Model(s)	Year	Eng. Code	Trans. Code	VIN Range From	VIN Range To
Jetta, Jetta Wagon	2009	2.0L TDI (CBEA, CJAA)	All	All	All
Jetta Sedan, Golf, Jetta SportWagen	2010-2012	2.0L TDI (CJAA)	All	All	AII
Passat	2012	2.0L TDI (CKRA)	All	All	All

**26 13 03** March 22, 2013 **2031583** Supersedes T.B. V261301 dated February 22, 2013 to add gasket part number.

MIL ON - DTC's P047F, P0477, P048A, P048B, P048C or P0401 Stored in ECM Fault Memory

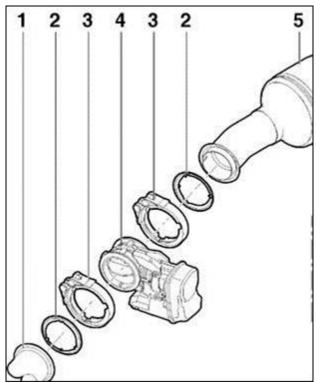
1. If one or more of the following faults are stored in the ECM fault memory, remove the exhaust flap to check for a sticking condition. (Item 4).

If the flap cannot be moved or does not move freely, the exhaust flap must be replaced.
